PUBLIC HEARING
CENTRAL MA CRANE-JACK DAIGE
SPR-2014-01 – MODIFICATION
Original Submittal

**Re: Central Mass Crane - 2024 Site Plan Modification: Proposed Storage-Garage Bldg.
112 Huntoon Memorial Highway; Parcel IDs: 44-A-10 and 46-A-1.2**

**Re: McClure Response to Quinn Engineering Peer Review comments date 2/22/24
Central Mass Crane - 2024 Site Plan Modification: Proposed Building
112 Huntoon Memorial Highway; Parcel IDs: 44-A-10 and 46-A-1.2**

C-1

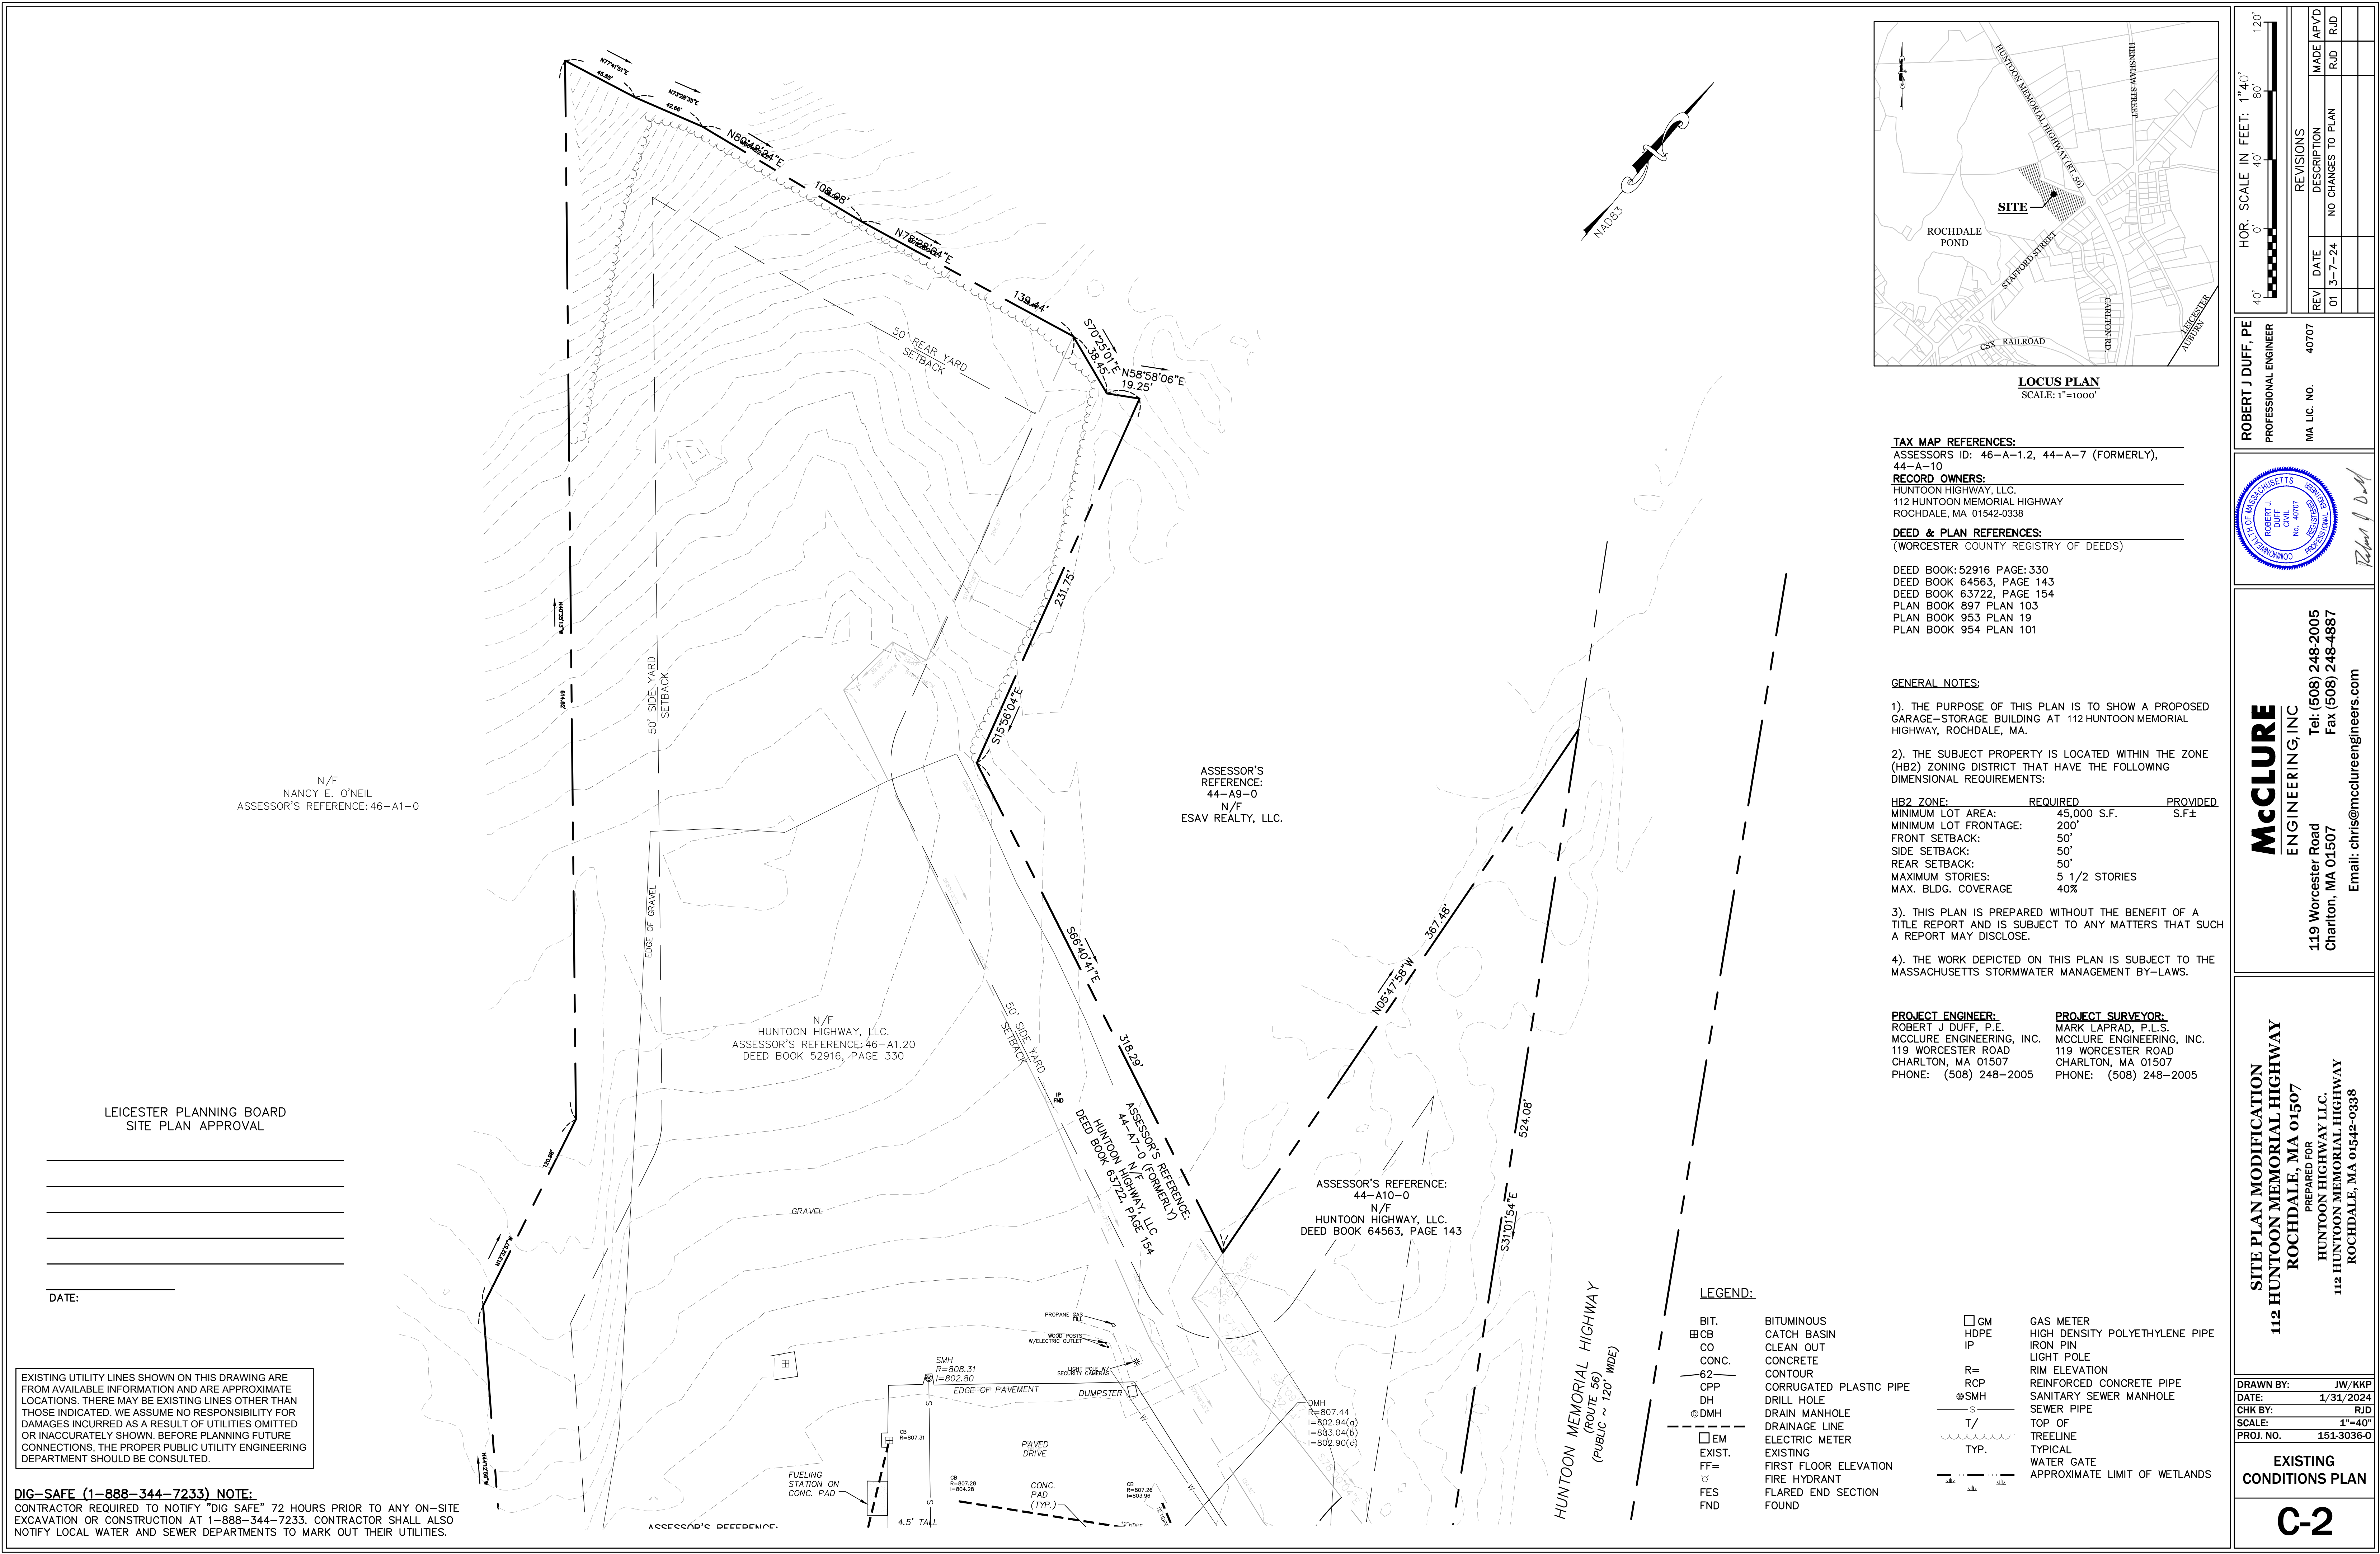
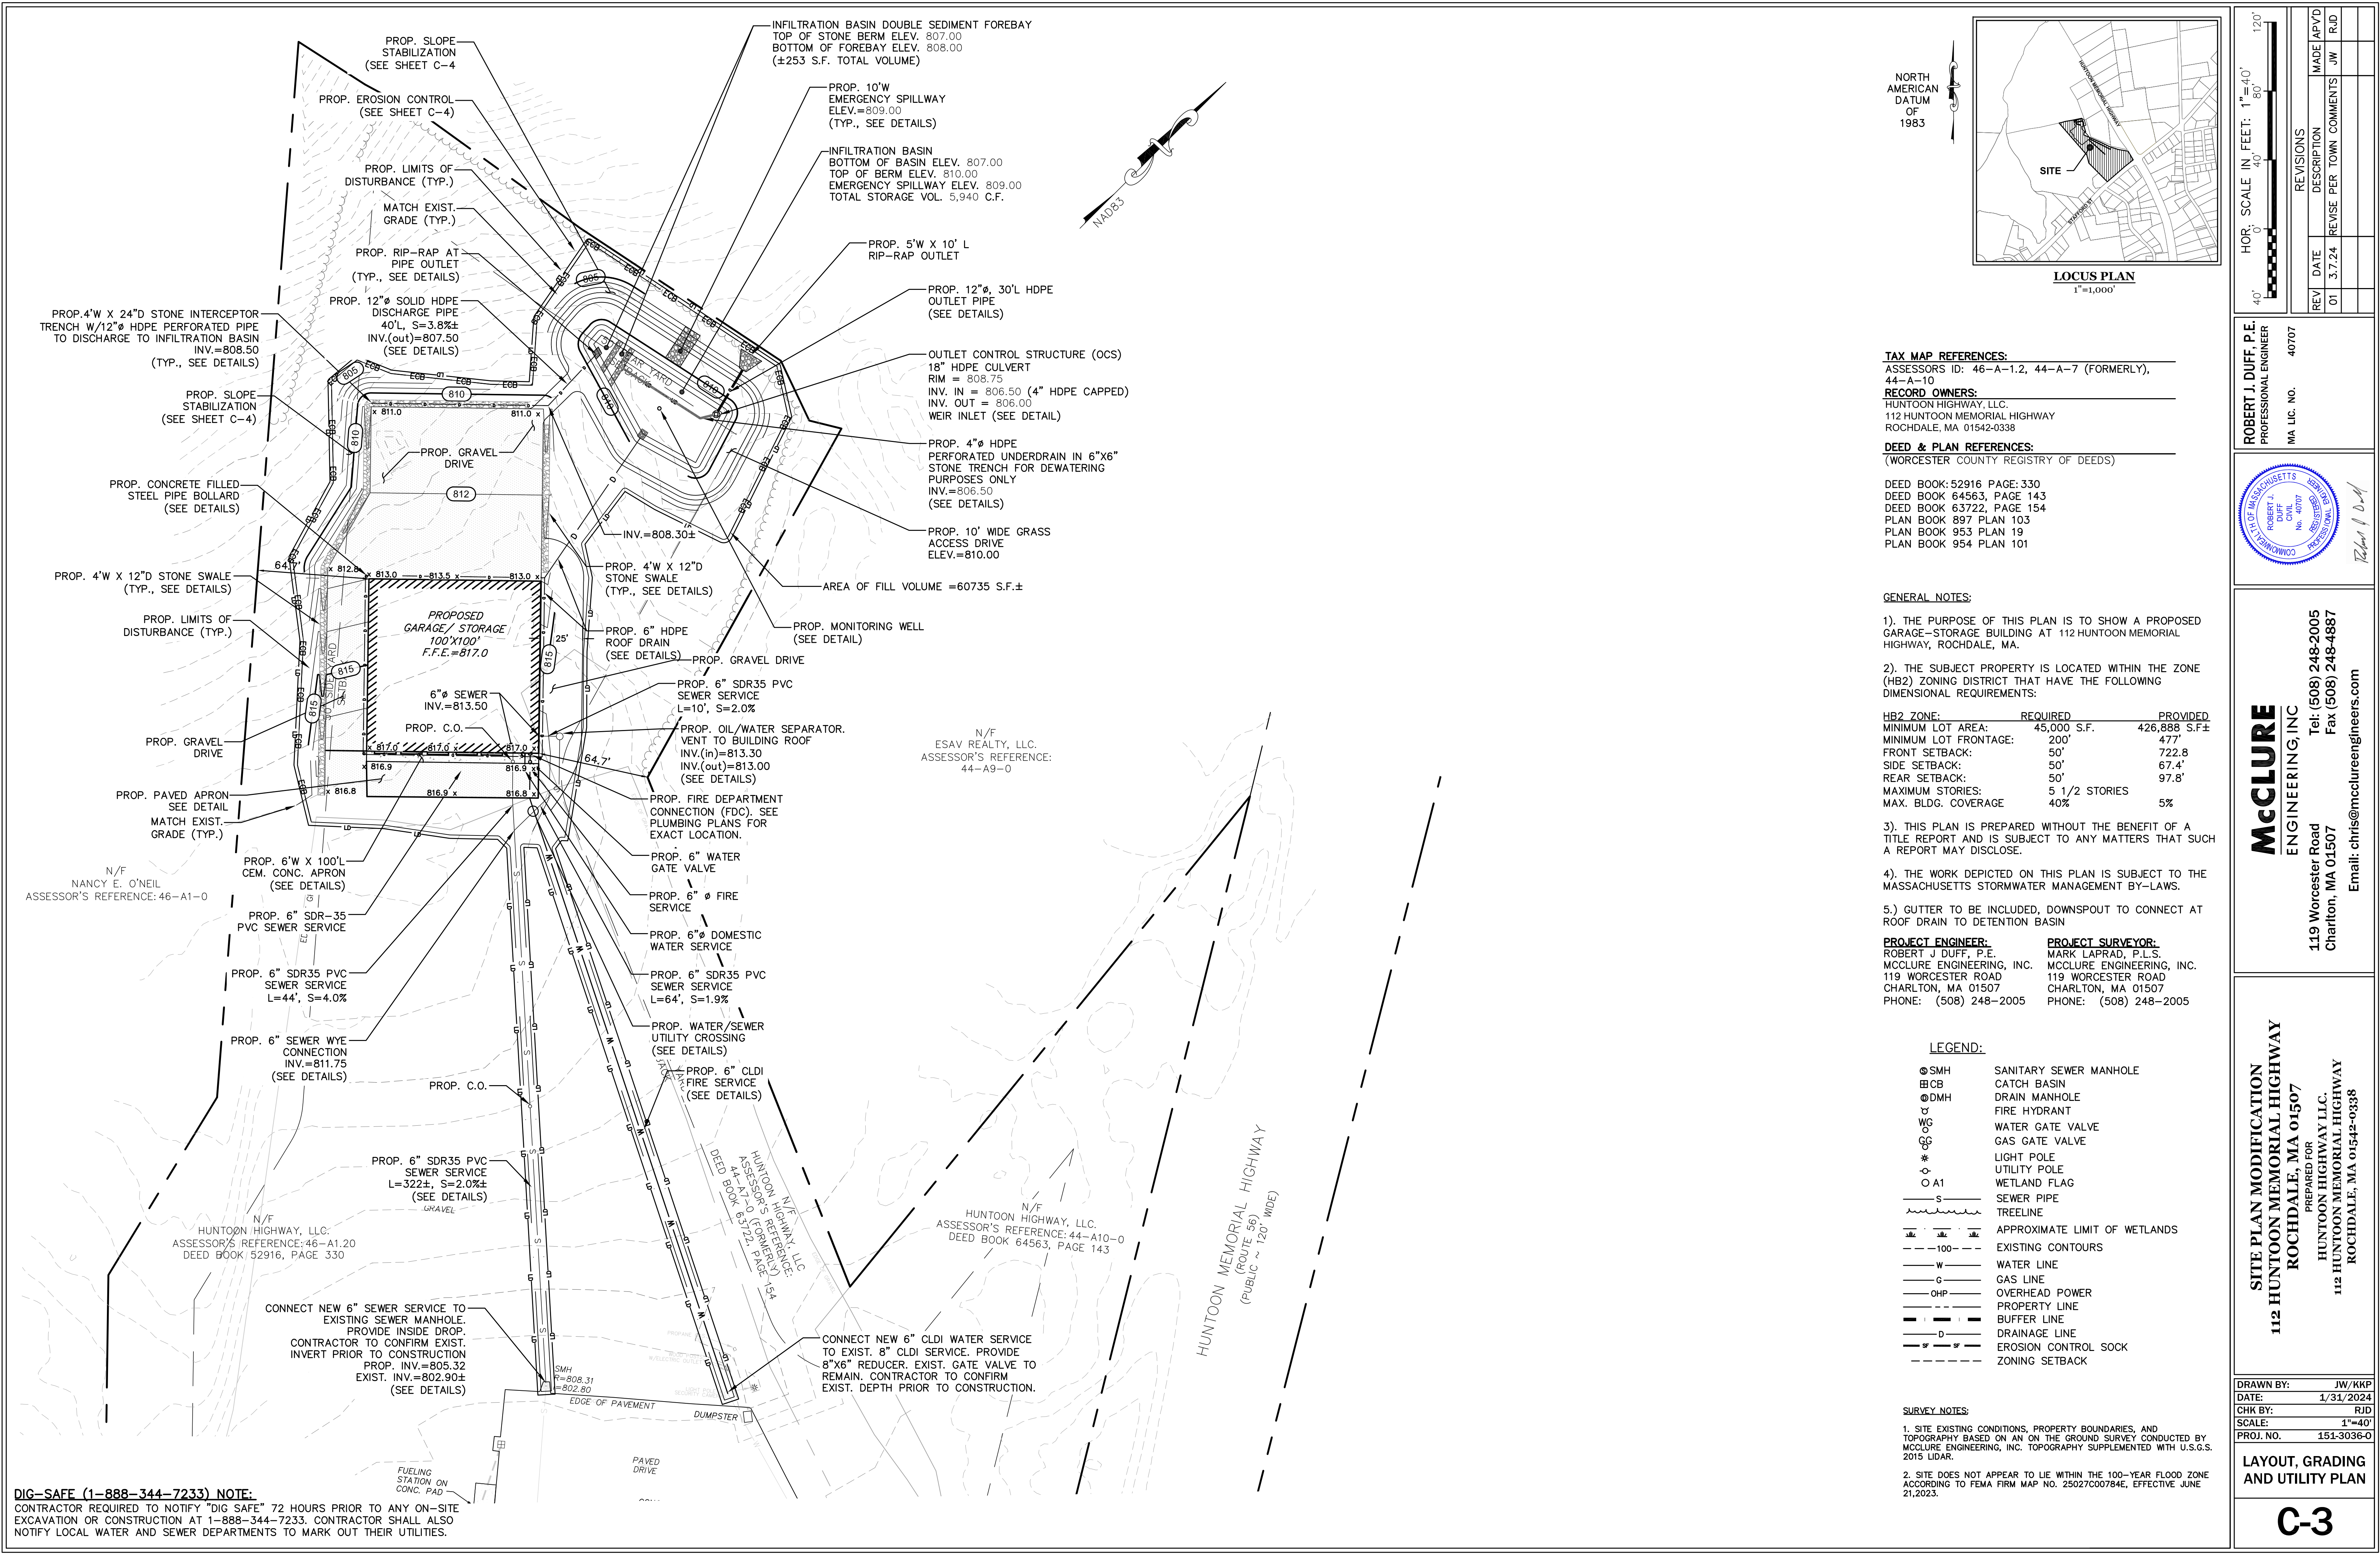
- b.) Location where earth removal or filling is proposed, and volume of material to be moved not found. (REF: Site Plan Review Regulations, Section II, F, 9)
McClure Response: Area of fill has been added to Sheet C3. The preliminary estimate is approximately 5,000 to 6,000 CYD of material will be imported,

McClure Response: Note added to Sheet C3. Downspout Detail added to Sheet C6
